PROJECT: City Stop #11

CITY OF LAS VEGAS		DATE:
INTER-OFFICE MEMORANDUM		October 10, 2012
TO: Land Development Services Department of Public Works		FROM: Albert Sung, P.E. Flood Control Project Engineer Department of Public Works
SUBJECT:	Drainage Study for:	
	City Stop #11	
Cross Streets:	SWC of Elkhorn Road & Hualapai Way	
File Number:	F:\Depot\DSMemos\DS4573A.doc	
Parcel Number:	126-24-517-004	
Zoning Action:	SDR-44850	
FEMA Flood Zone	YES	NO X
Proposed Storm Drain	YES	NO X
		COPIES TO: Baughman & Turner, Inc. Providence Plaza, LLC Bart Anderson, P.E., DevCo CCRFC

**TECHNICAL DRAINAGE STUDY FOR
CITY STOP #11
SECTION 24, TOWNSHIP 19 SOUTH, RANGE 59 EAST
CITY OF LAS VEGAS, NEVADA**

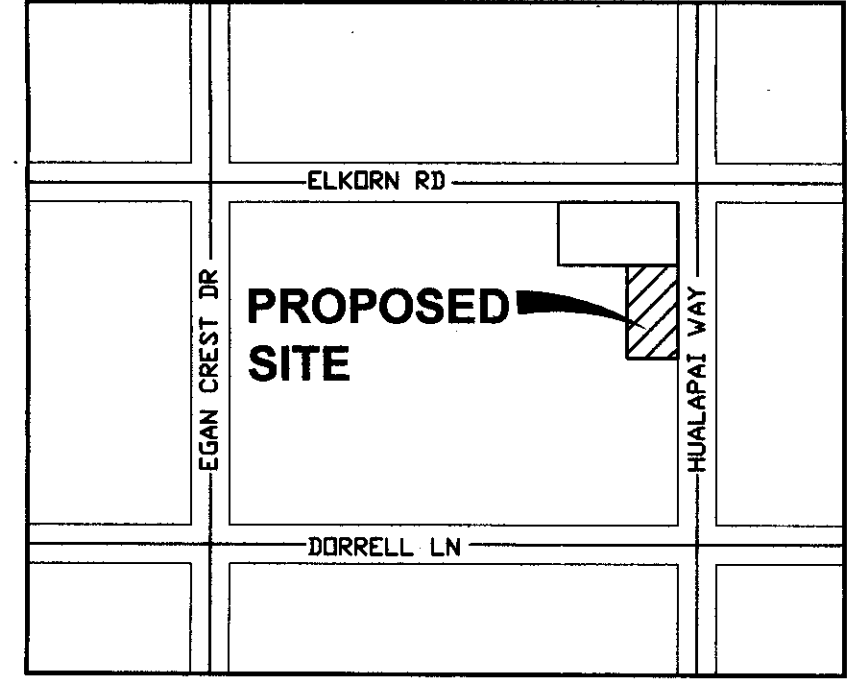
Show how the Landscape drains? with PL @ regular intervals

A

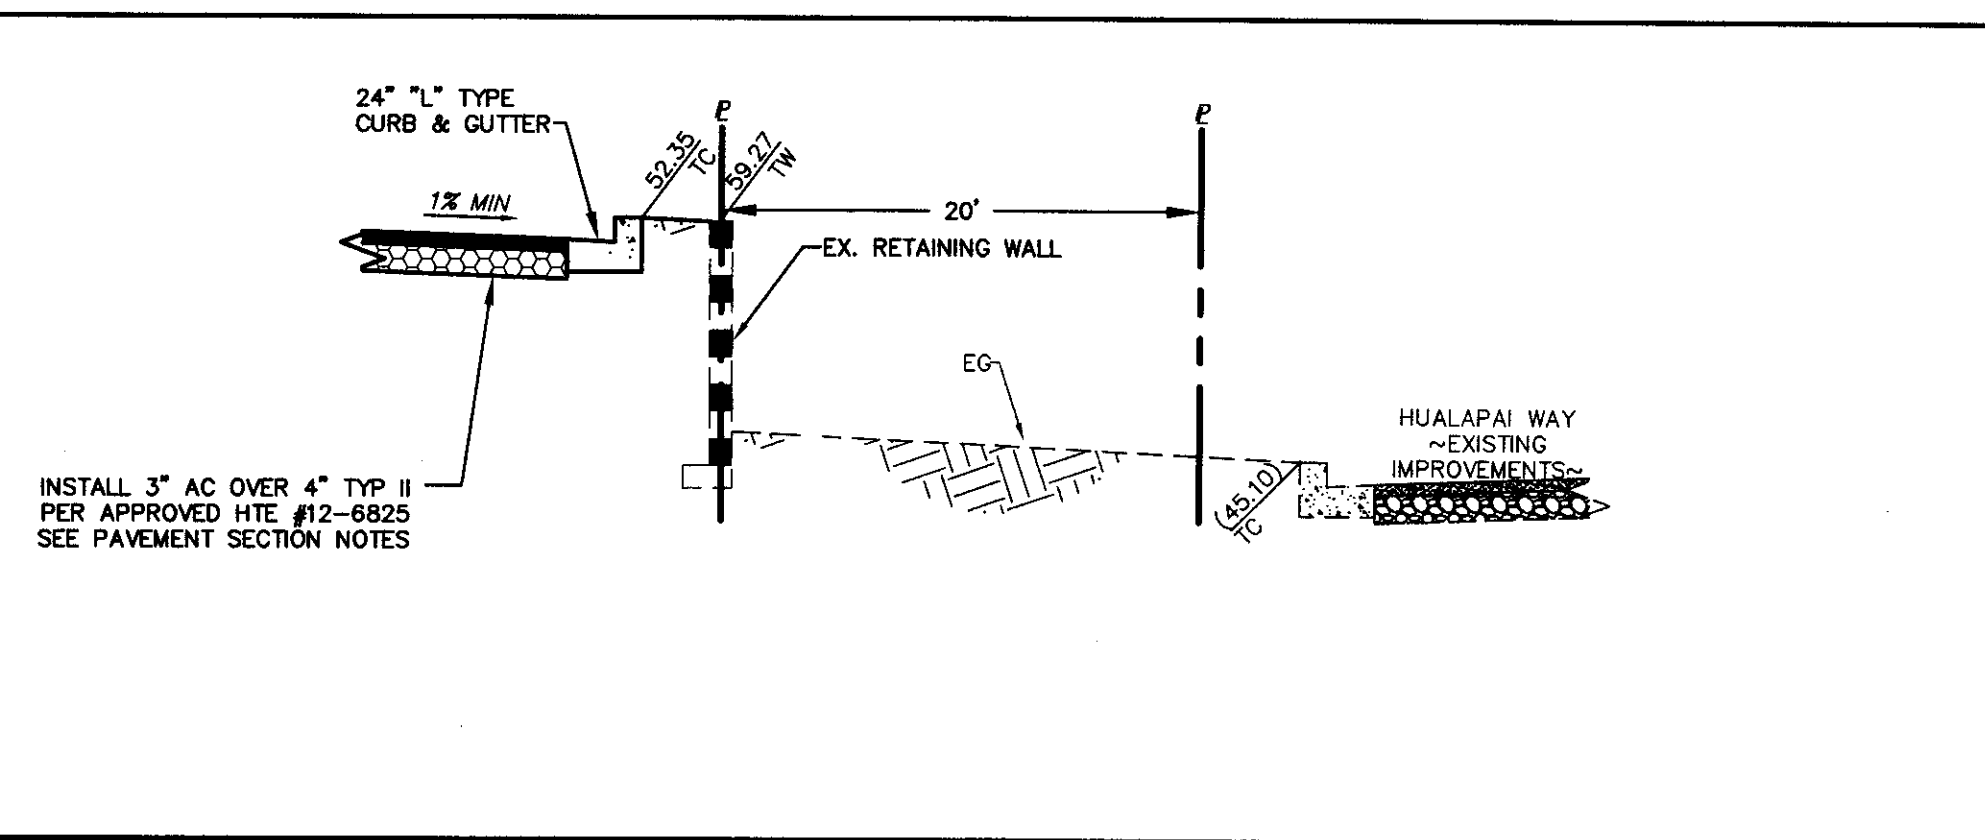
2. Per *Section A/DT1*, a flow line is proposed in the landscape area between an existing retaining wall and a proposed onsite drive. However, the flow line is not found in the grading plan. Show the flow line and label with FL elevations at regular intervals.

C

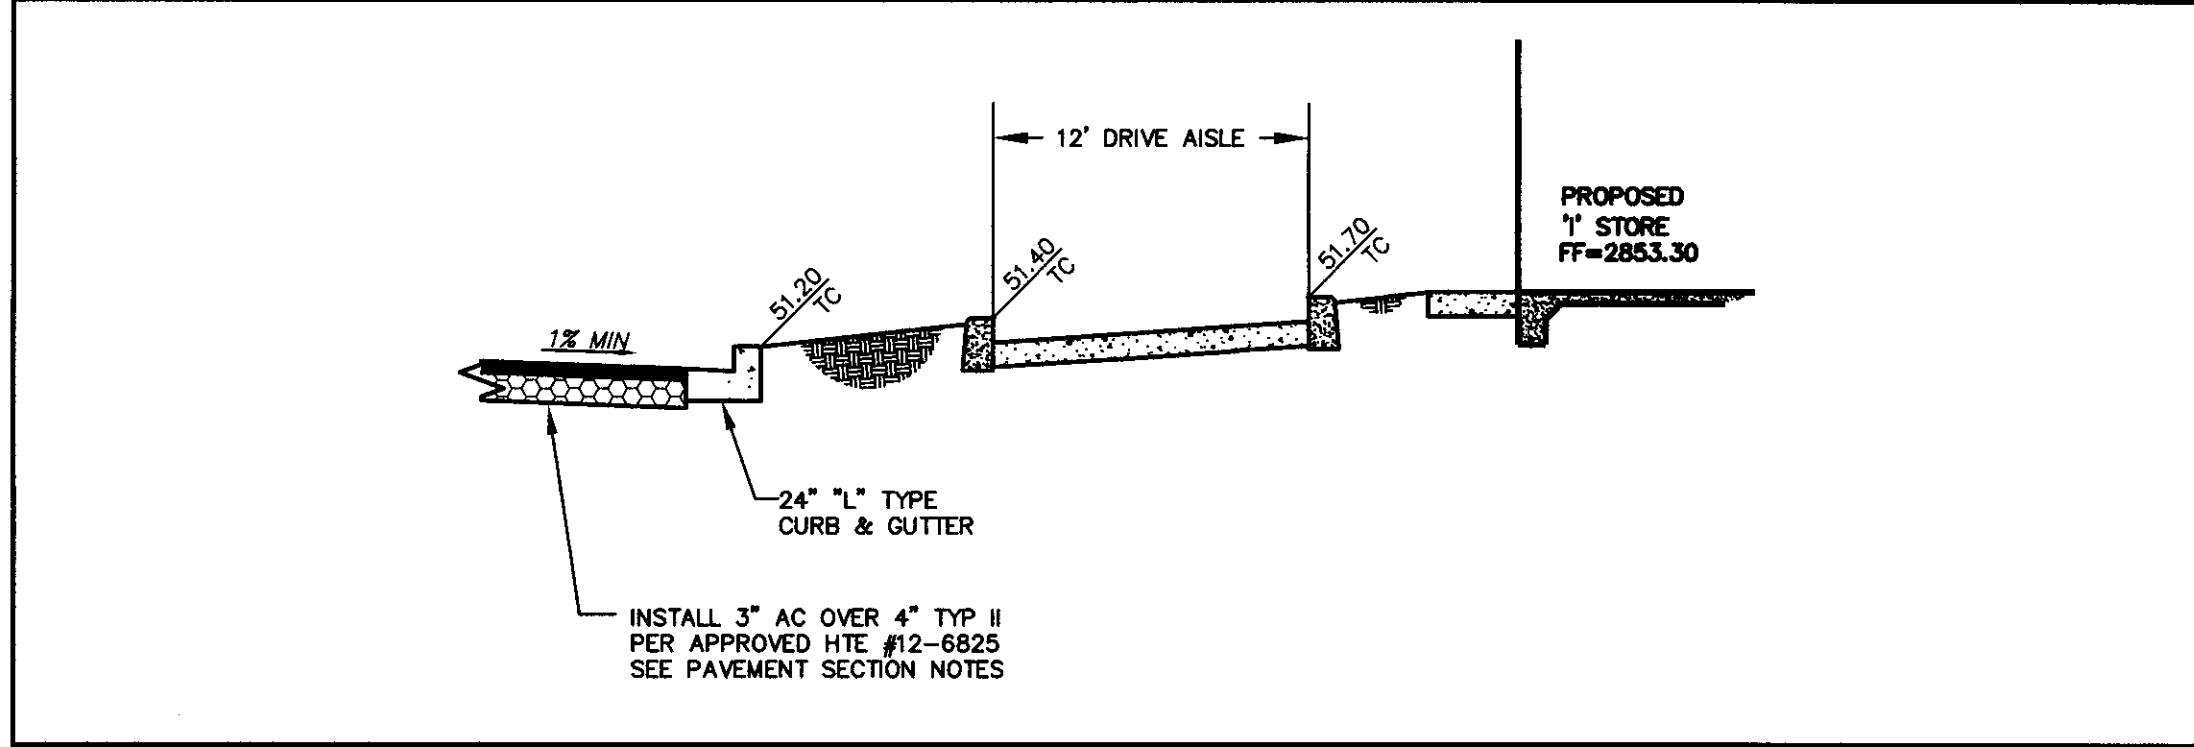
3. *Section C/DT1* shows a flow line right at the property line between the two parcels. This will create a maintenance responsibility problem in the future. Position the flow line to be completely within the subject property. Revise the section and show the flow line on the grading plan accordingly.

F

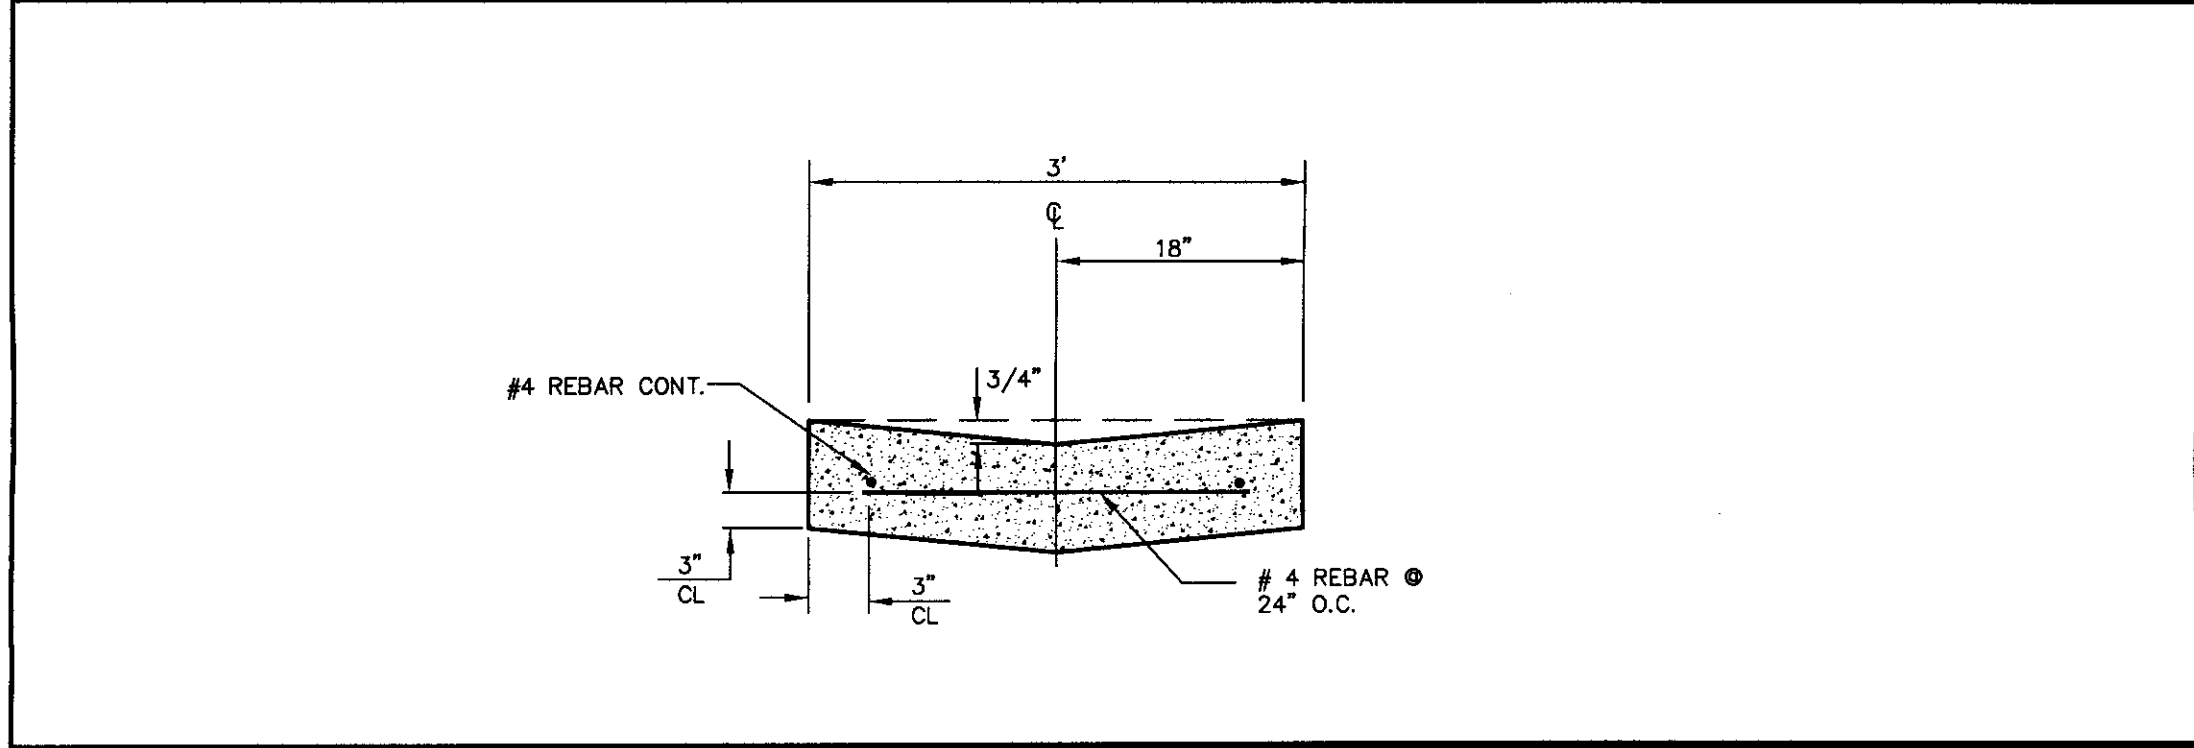
4. The location of *Section F/DT1* on the grading plan appears to not matching what is shown in the detail. Review and revise accordingly.
5. *Section G/DT1* is missing in the detail sheet. Provide as such in the next submittal.
